Project	IEEE 802.16 Broadband Wireless Access Working Group < <a href="http://ieee802.org/16">http://ieee802.org/16</a> >
Title	<b>Improved method for using EESM for CINR Measurements</b>
Date Submitted	2005-03-14
Source(s)	<p>Kevin Baum <a href="mailto:Mark.Cudak@motorola.com">[mailto: Mark.Cudak@motorola.com]</a>  Yufei Blankenship  Brian Classon  Mark Cudak  Philippe Sartori</p> <p>Motorola Labs  1301 E. Algonquin Road  Schaumburg, IL 60196</p>
Re:	IEEE P802.16e/D6, sponsor ballot
Abstract	This contribution comments on the limitations of a recently proposed design for using EESM to provide CINR measurement and proposes an improved design.
Purpose	Adoption of proposed changes into P802.16e
Notice	This document has been prepared to assist IEEE 802.16. It is offered as a basis for discussion and is not binding on the contributing individual(s) or organization(s). The material in this document is subject to change in form and content after further study. The contributor(s) reserve(s) the right to add, amend or withdraw material contained herein.

## Comments on the Use of EESM method for CINR Measurements

Figure 1. Effective SNR (dB) as a function of  $\gamma$  (dB) (independent Rayleigh fading, average SINR of 10 dB).

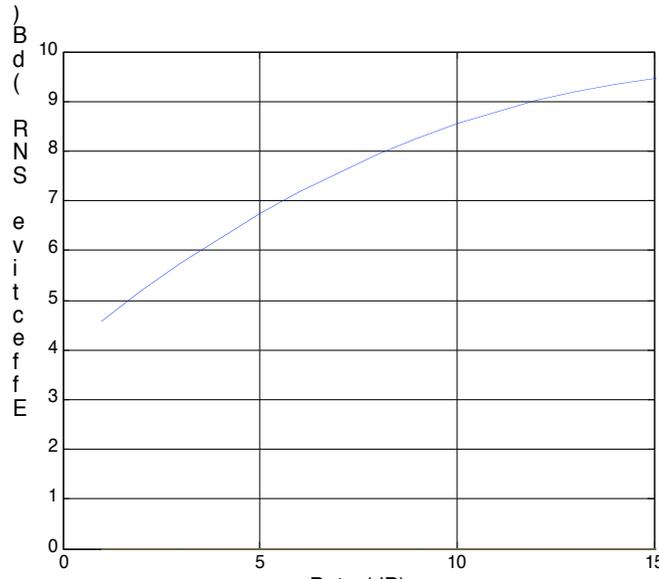
In [1], a linear dependency between the effective SNR (dB) and  $\gamma$  (dB),  $\gamma < 15$ dB, is hypothesized. However, this hypothesis is based on observations over a very limited set of simulation conditions. The example given in [1] assumes that the channel is independently Rayleigh faded on every subcarrier and the only SNR considered is 10 dB.

In the following, various channel types were studied to check the validity of the linear assumption. The plots are shown with  $\gamma$  in the range of 0 dB to 15 dB, since for modulation and coding schemes defined in the standard, the  $\gamma$  value (linear) ranges roughly from 1 (close to  $\gamma$  of QPSK, rate 1/2) to 30 (close to  $\gamma$  of 64-QAM, rate 3/4). As a check of our simulation setup, we first show our simulation results with exactly the same assumptions for a single channel realization<sup>1</sup> in Figure 1. As it can be observed from Figure 1, a more or less linear dependency is observed up to a  $\gamma$  value of 15 dB, although there is some degradation for  $\gamma$  larger than 9 dB.

Figure 2. Effective SNR as a function of  $\gamma$  (independent Rayleigh fading average SINR of 6 dB).

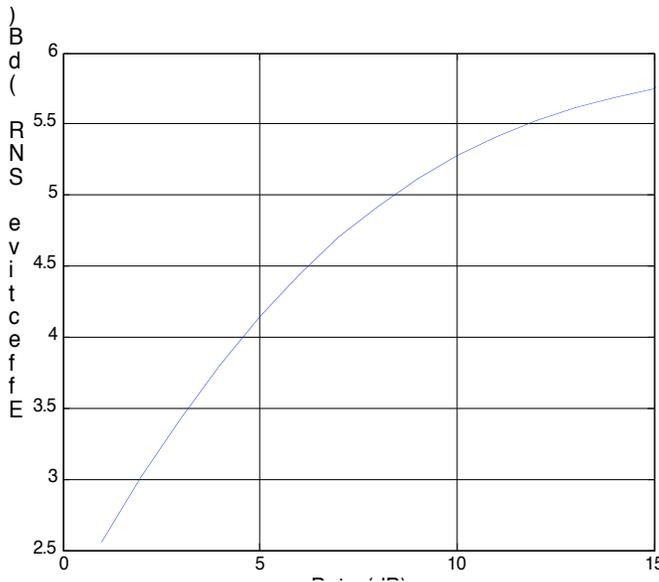
However, it should first be noted that the range on which the linear approximation is valid is fairly limited. As an example, Figure 2 shows the effective SNR vs.  $\gamma$  for Rayleigh fading and a lower average SINR of 6 dB. These results show an approximately linear relationship for a small region of  $\gamma$  between 1 dB and 5 dB. When considering the  $\gamma > 5$  dB region as well, the nonlinearity becomes significant.

Figure 3. Effective SNR (dB) as a function of  $\gamma$  (dB) (Ped A channel, average SINR of 5 dB).

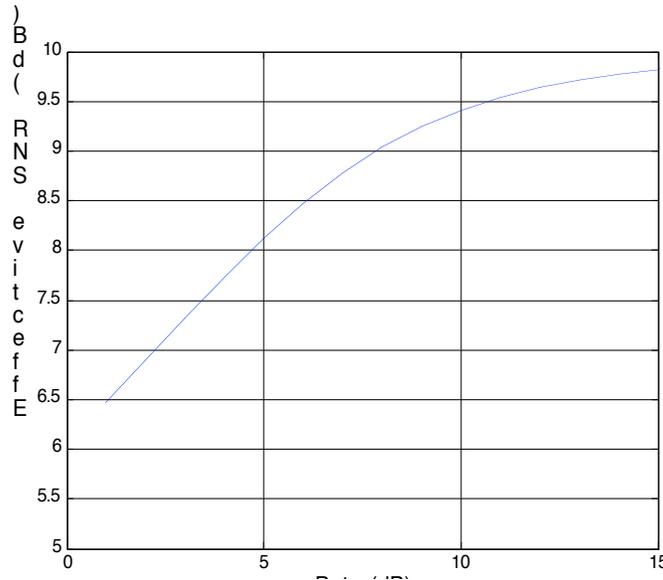
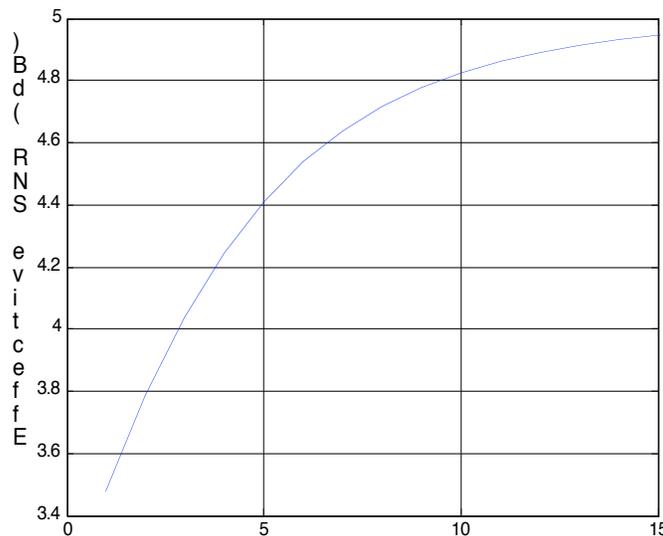
Next, we investigate the characteristics over a more realistic channel model rather than the simplified model used above. In practice, the frequency response of the channel is correlated over several subcarriers. It is therefore important to look at the effective SNR vs.  $\gamma$  for channels having such correlation. One channel often used for the 3G evaluation is the 3GPP Pedestrian A (Ped A) channel. Figure 3 and Figure 4 depict the effective SNR (dB) as a function of  $\gamma$  (dB) for the Ped A channel, for an average SINR of 10 dB and 5 dB, respectively.

Clearly, for the Ped A channel, it is inaccurate to consider that the dependency between the effective SNR and  $\gamma$  (dB) is linear for the entire range of  $0 \text{ dB} < \gamma < 15 \text{ dB}$ . For instance, for a received average SINR of 10 dB, the curve appears linear only over a couple of dB width at a time. For a system like 802.16 where 16-QAM and 64-QAM are defined, the  $\gamma$  difference for two consecutive Modulation/Coding Schemes (MCS) is larger than 2 dB.

In conclusion, though the EESM method is promising for improving MCS selection, the feedback method proposed in [1] should be improved to provide better accuracy over a wider range of  $\gamma$  values.

Figure 5. Quadratic (dashed line) vs. linear (cross) curve fitting for the GSM TU channel.

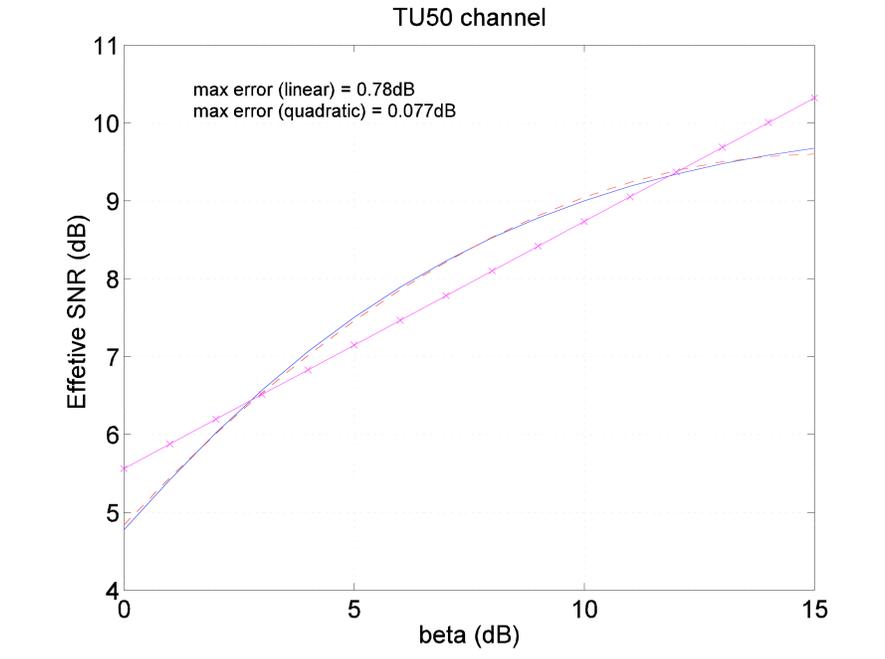
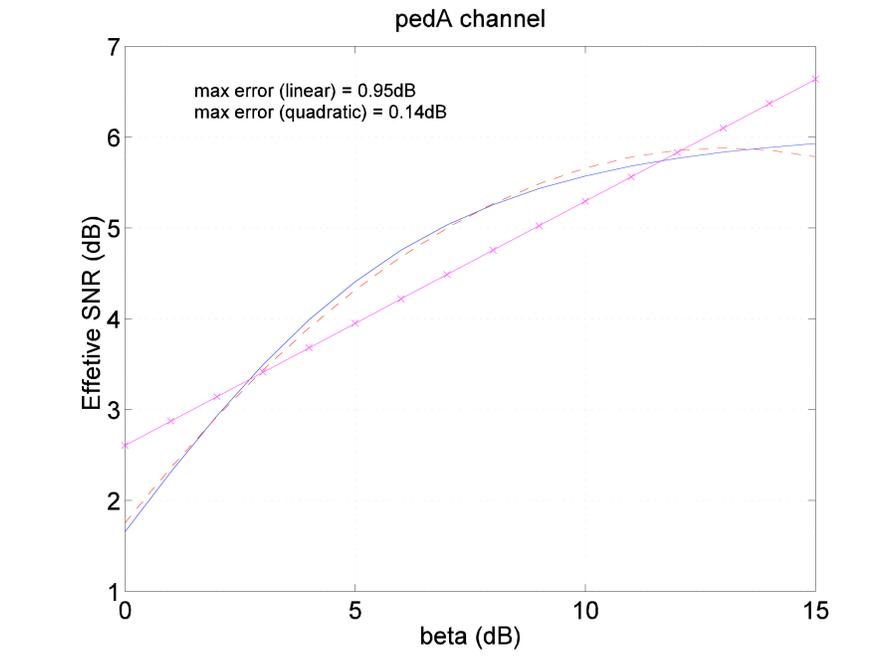
The fading channel curves shown in Figure 5 and Figure 6 illustrate that the quadratic approximation is more accurate than the linear approximation in the  $\beta$  (dB) range of interest. In fact, the quadratic approximation leads to an almost perfect curve fitting (a few hundredths of a dB, not noticeable when practical limitations are taken into account). It is important to minimize the curve-fitting error, because this easily controllable error is in addition to the EESM method error which is very difficult to further reduce. Since the EESM method error is less than 0.5 dB for all the 802.16 MCS, the advantage of using EESM will be lost if the curve-fitting error is more than a fraction of 0.5 dB. Note that in Figure 5 and Figure 6, the slope of the linear approximation was selected to minimize the mean-square error (under the linear curve constraint) over the entire  $\beta$  range of [0 dB, 15 dB]. If the slope local to a specific  $\beta$  value was used instead (as suggested in [1]), then errors on the order of several dBs may occur.

Although many type of curve fitting,  $SNR_{eff}=F(\beta)$  where  $F(\beta)$  is a nonlinear function of  $\beta$ , could be used in theory, it is necessary to limit the amount of feedback the mobile has to send to the BS. As an example of the function  $F(\beta)$ , a quadratic curve fitting can be employed to provide very good accuracy. The  $SNR_{eff}$  (dB)-  $\beta$  (dB) relationship can be approximated by:

$$SNR_{eff}(\text{dB}) = a + b\beta + c\beta^2, \tag{1}$$
